SOIL/SITE EVALUATION

ON-SITE WASTEWATER SYSTEM

APPLICANT: JOHN A. RHEW OWNER: _____ AGENT: _____ PHONE: 919-779-7677
 ADDRESS: 3916 W. ALLEN ST. APPLICATION DATE: 3/19/95 DATE EVALUATED: 4/2/95
RAL. NC 27603 PROPOSED FACILITY: 3 BEDROOM
 PROPERTY SIZE: 1.476 AC
 LOCATION OF SITE: HOLLY RIDGE DR. NEILLS CREEK FARM LOT 145
 WATER SUPPLY: On-Site Well _____ Comm. Well _____ Public ☒ Other _____ EVAL. METHOD: Auger Boring ☒ Pit _____

LOT 145

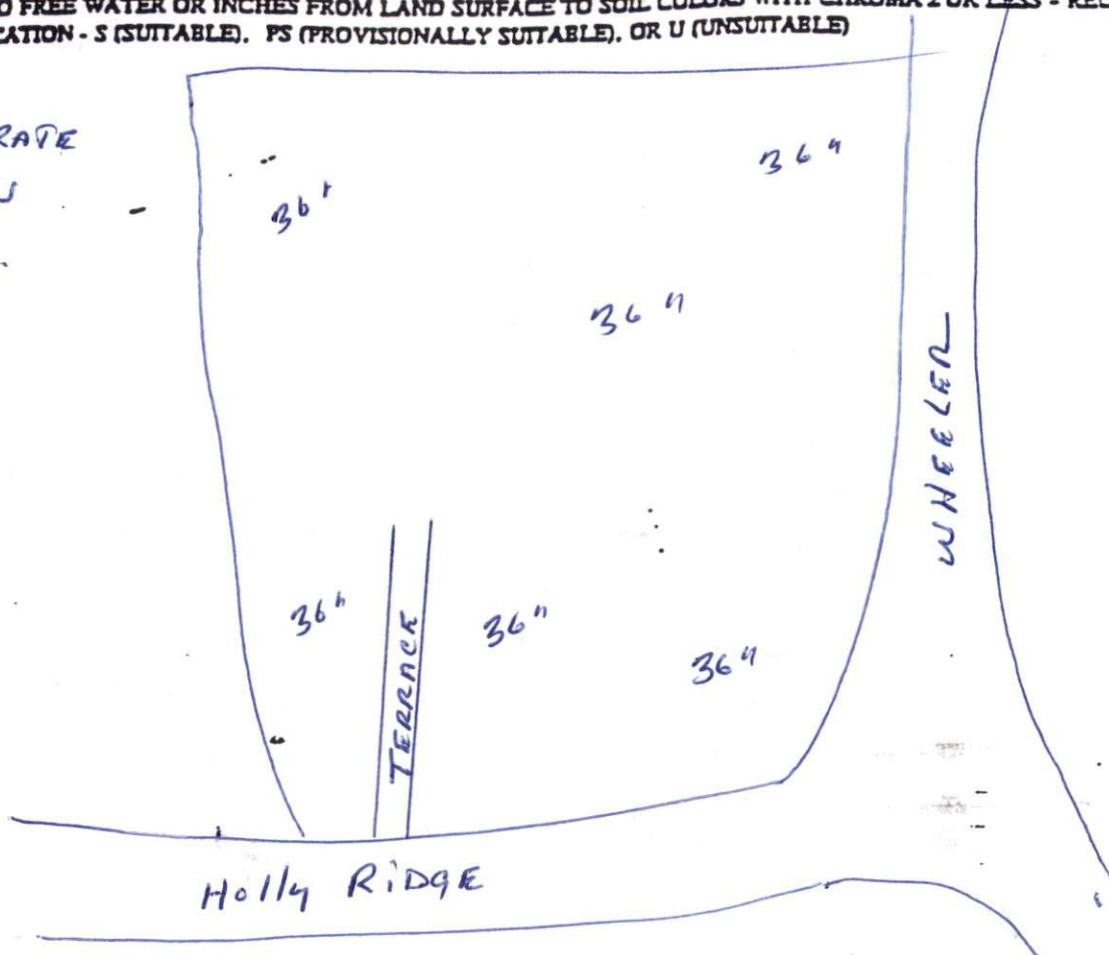
LOT SUITABLE FOR SHALLOW PLACE CONVENTIONAL.

LOT HAS SOME TOPO PROBLEM AS
FAR AS SEPTIC LAYOUT SLOPE &
EXISTING TERRACE

* MUST KNOW LOCATION OF GARAGE &
DRIVE BEFORE LAYOUT CAN BE DONE.

THIS WAS NOT SHOWN ON SIDE PLAN.
DRIVE + GARAGE NEEDS TO BE ON LT END OF
HOUSE FACING HOLLY RIDGEDR.
